KENWOOD

SERVICE BULLETIN AMATEUR RADIO

SUBJECT		DATE
TS-440S PLL UNLOCK DUI	TO VC05	08/08/90
1	the state of the s	1

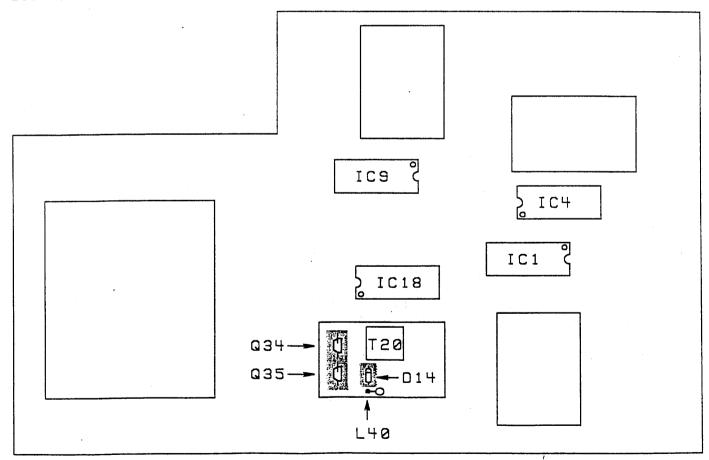
- 4. Remove the 8 screws from the PLL board and disconnect all the cables going to the board.
- Remove the board from the transceiver.
- 6. Remove the shield cover from VCO #5. Desolder and remove the shield from the PLL board.

- 7. Carefully remove the synthetic rubber from the area of Q34, Q35, and D14. The rubber must be picked off the board with pointed tweezers or some other tool. It cannot be removed with any type of solvent as this will harm the components in the area. You can heat the rubber with a hot air gun to allow it to be picked off a little easier, but be careful not to overheat the components in the area.

- Desolder and remove Q34, Q35, and D14 from the PLL board.
- 9. Check the component side of the board to make sure all the rubber in the area of Q34, Q35, and D14 is removed.

- 10. Once the rubber is removed, replace Q34, Q35, and D14 with new components.

- 11. Inspect and resolder the foil side of the PLL board under VCO #5.
- 12. Install the VCO shield on the PLL board and solder it in place.
- 13. Seal the VCO with hot melt glue (glue stick used in a hot melt glue gun). Apply the glue to the circuit from the glue gun. Once the area is covered, use the hot air gun to flow the glue around the components. Do not overheat the components.
- 14. Install the PLL board in the transceiver.
- 15. Apply power to the transceiver and allow it to run in receive for about a half hour so the transceiver's temperature stabilizes.
- 16. Set the operating frequency to 14.200MHz.
- 17. Adjust T20 to obtain 5VDC at TP11 (the exposed lead of L40) measured with a DVM or VTVM. Do not use a VOM. After adjusting the VCO, bench run the transceiver for an hour or more to make sure the circuit is stable.
- 18. Assemble the transceiver.
